South Texas Project Electric Generating Station 4000 Avenue F – Suite A Bay City, Texas 77414

February 10, 2010
U7-C-STP-NRC-100036

South Texas Project
Units 3 and 4
Docket Nos. 52-012 and 52-013
Response to Request for Additional Information

Attached are the responses to the NRC staff questions included in Request for Additional Information (RAI) letter numbers 299 and 302 related to Combined License Application (COLA) Part 2, Tier 2, Sections 3.7.1, 3.7.2 and 3.8.4.

Figure 03.07.01-20a

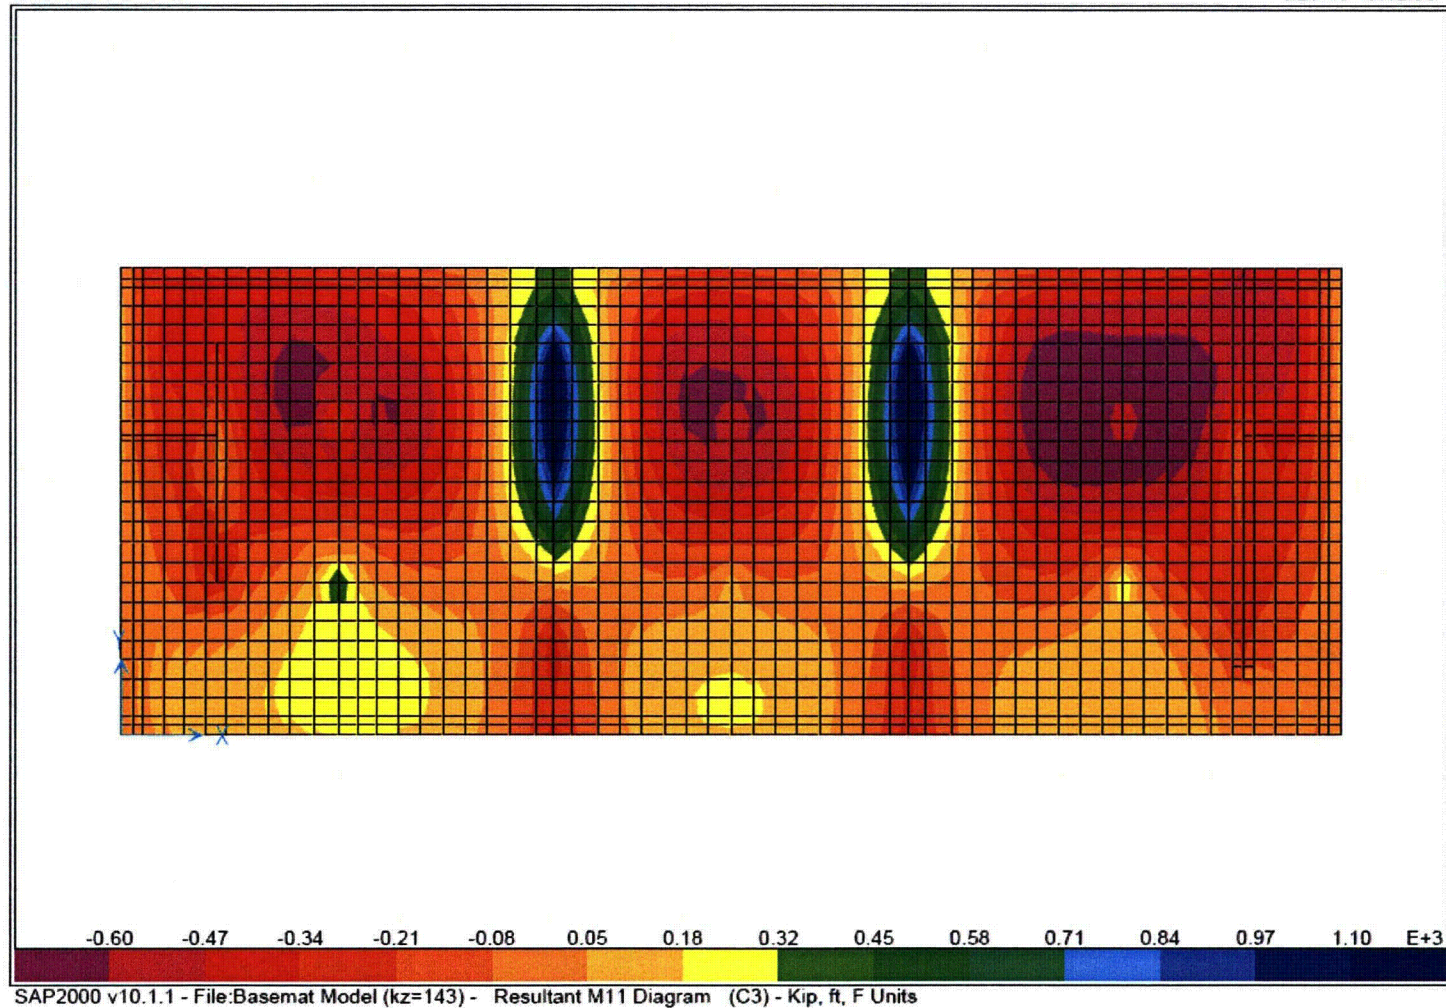
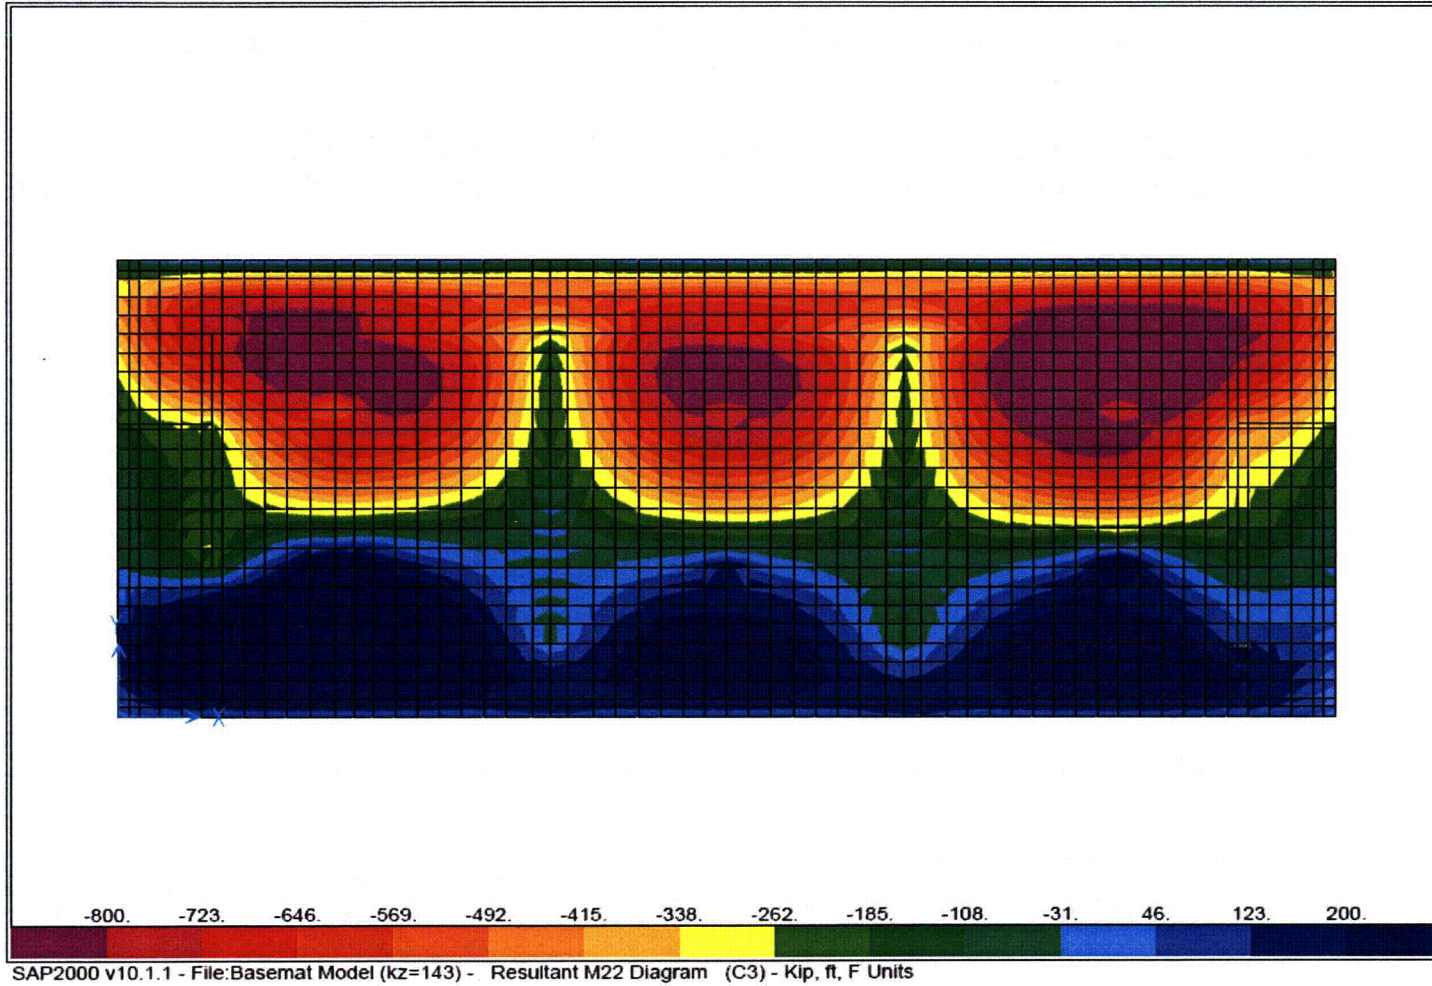
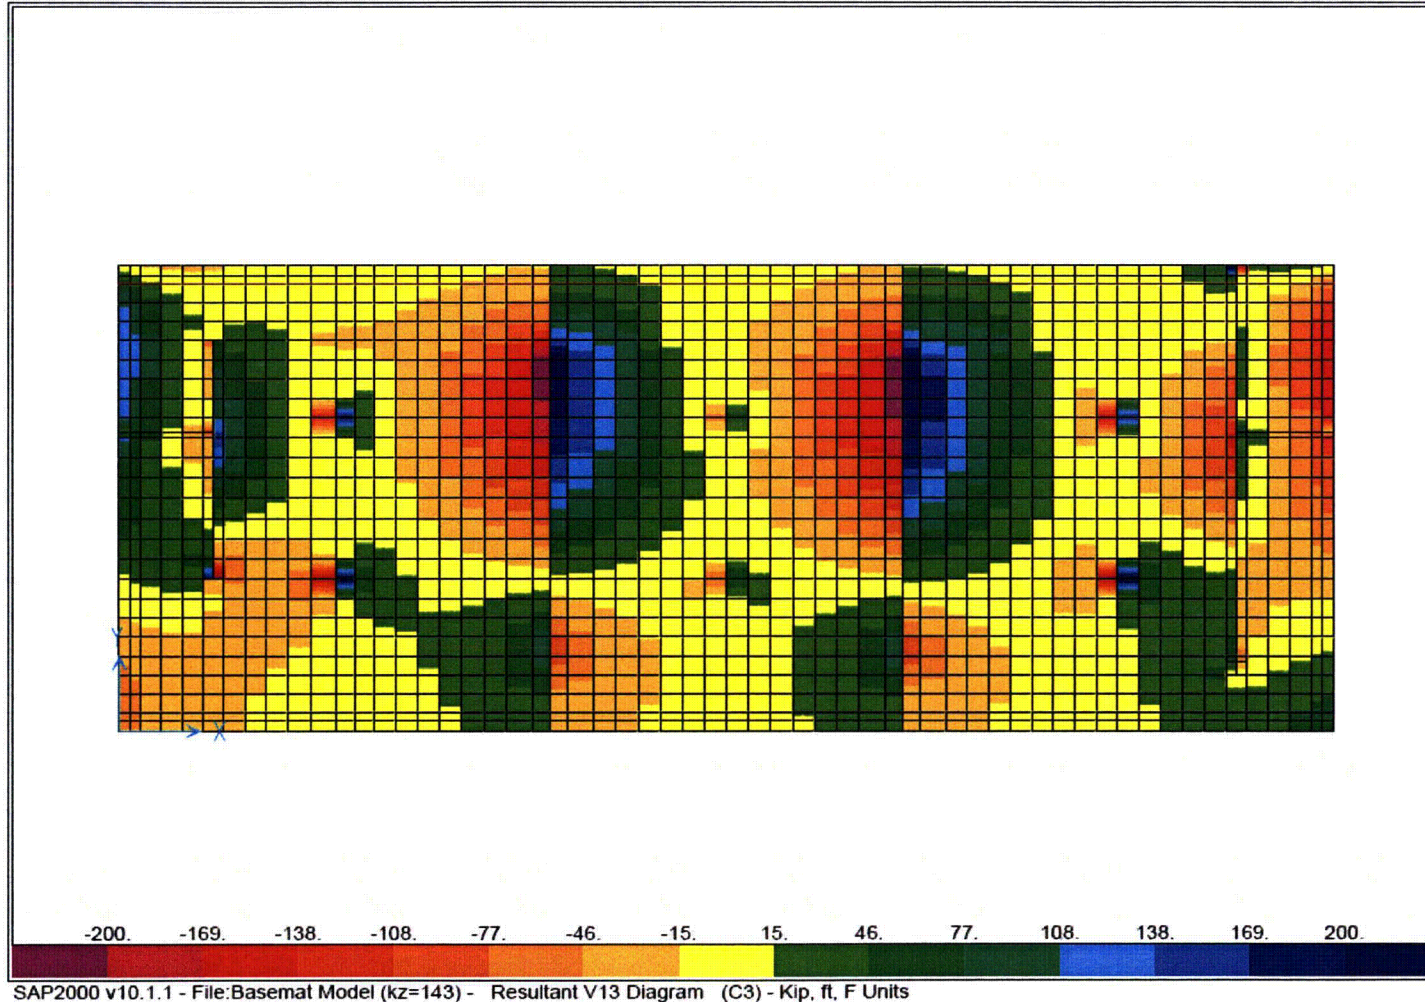
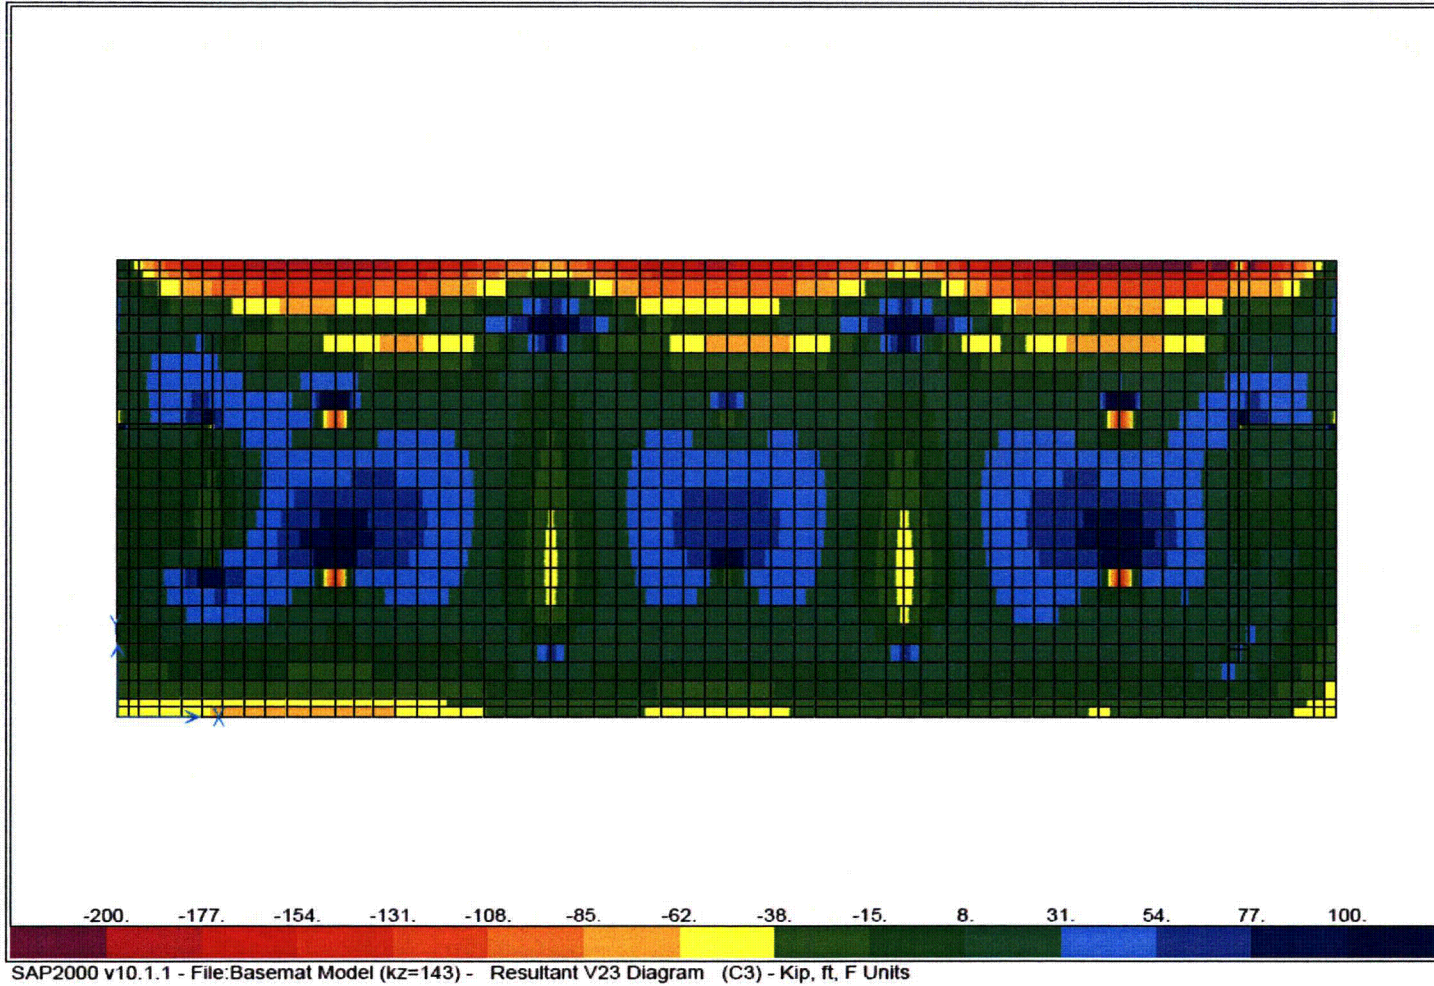
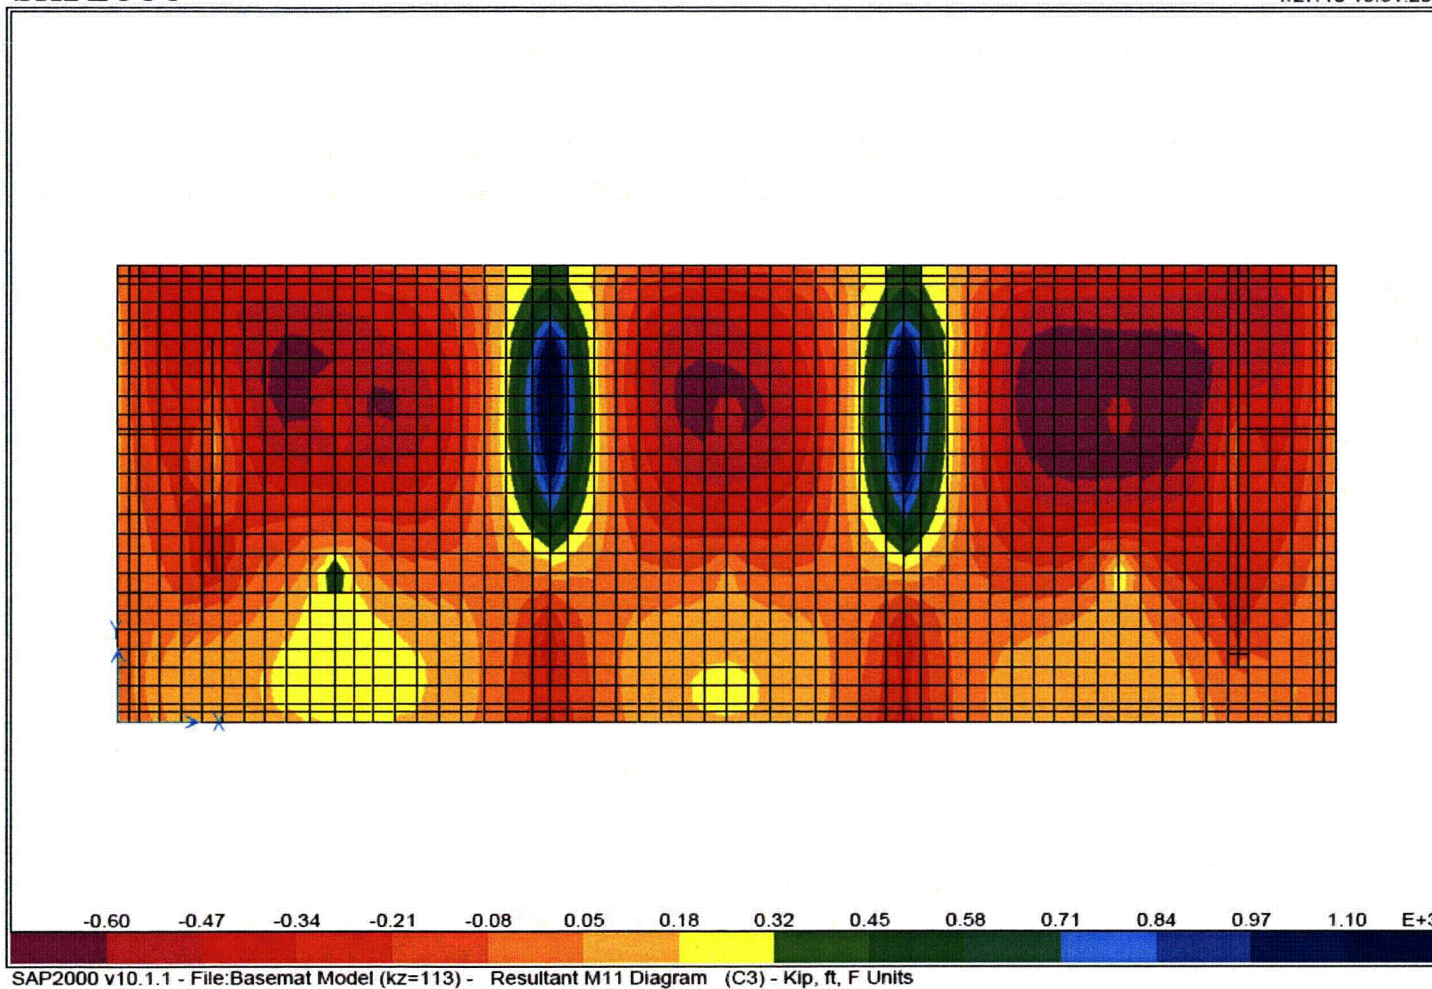
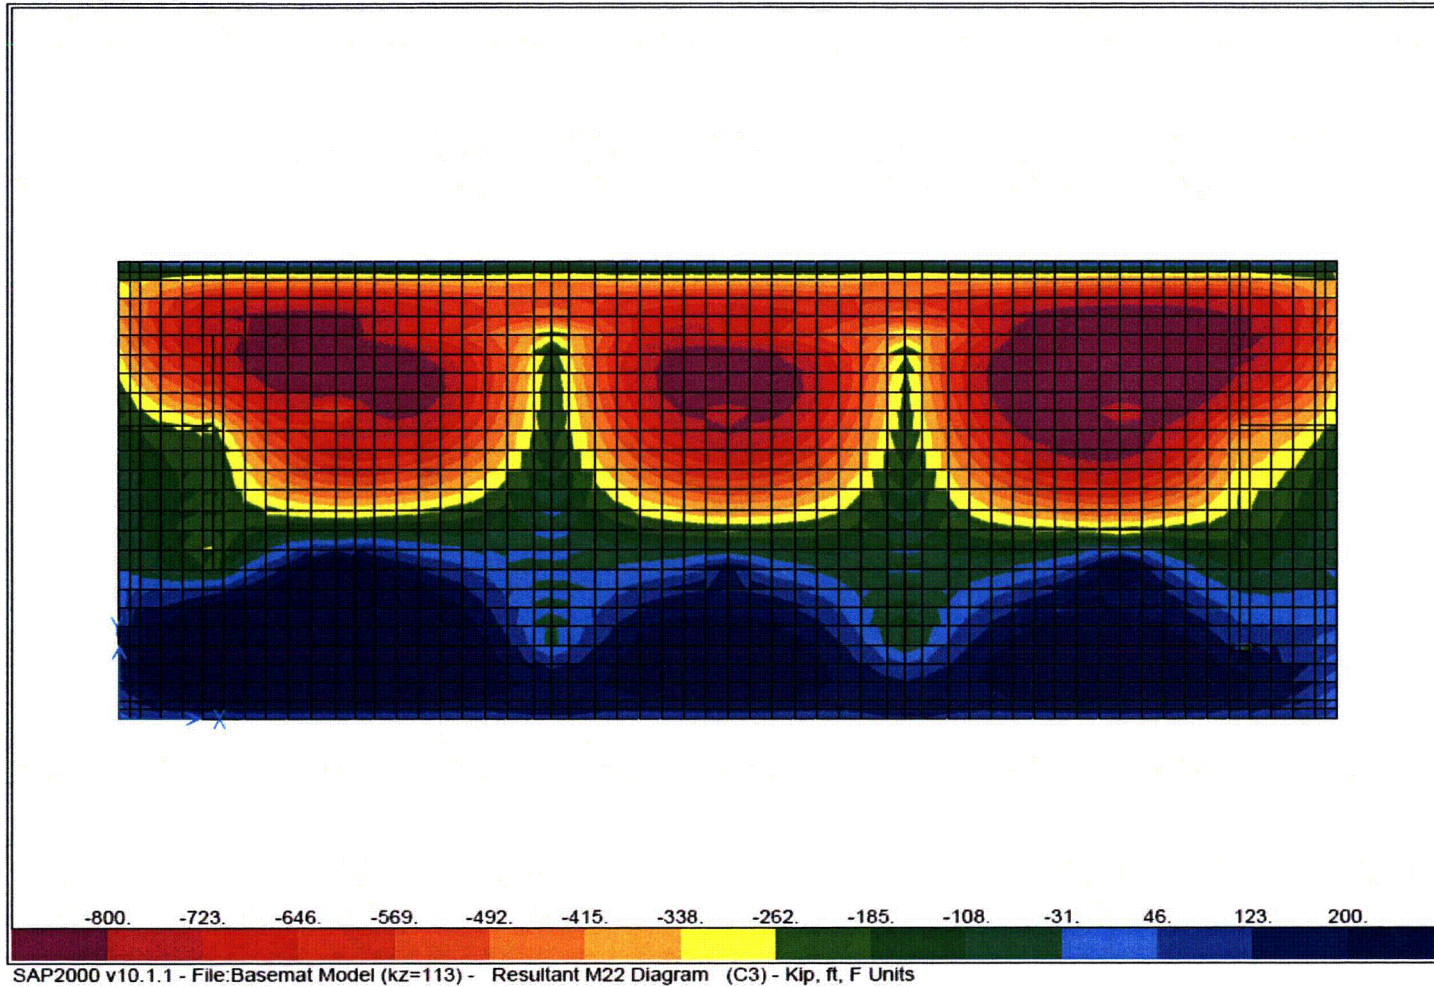
- (2) In the response to RAI 03.07.01-7, the applicant stated that "*The spring constant values are provided only for the Reactor Building in the DCD. Therefore, a comparison of the spring constant values is provided only for the Reactor Building.*" This justification for not evaluating the effect of site-specific shear wave velocity on the Control Building (CB) foundation design is not acceptable. The applicant is requested to further justify that the design of the CB foundation at the STP site would still be bounded by the standard plant CB design.

As noted in part (2a) of this response, the calculated STP site-specific soil spring constants for the upper range and best estimate cases are the same as, or higher than, the best estimate soil spring constants used for the standard design. Higher soil spring constants at the STP site will result in mat design forces smaller than those used for the ABWR CB design. The lower range site-specific soil spring constants are lower than the best estimate DCD spring constants. However, even with lower range site-specific spring constants, the ABWR CB mat design is adequate for the STP site for the following reasons:

- Considering the size and geometry of the CB, arrangement of the exterior and interior shear walls, thickness of the shear walls (39 inch exterior walls and 63 inch interior walls), and the mat thickness (i.e. 118 inches), the CB mat design is quite rigid and not so sensitive to spring constant values. This can be seen from the parametric study results presented in Figures 03.07.01-20a through 03.07.01-20i provided with this response.

Figure 03.07.01-20a shows the layout of the mat and the shear walls of a structure with very similar arrangement to that of the DCD CB. The model used for this parametric study is a three dimensional finite element model. This model was analyzed twice for the total dead load of the structure along with significant seismic moment about the X-axis (along East-West), once with DCD best estimate spring constants and the second time with lower bound site-specific spring constants. Figures 03-07-01-20b through 03-07-01-20e present contour plots of the resulting out-of-plane moments and shears when using DCD spring constants. Figures 03-07-01-20f through 03-07-01-20i present contour plots of the resulting out-of-plane moments and shears when using lower range site-specific spring constants. Comparison of the resulting out-of-plane moments and shears from these two cases show that there is no significant change in mat design forces.
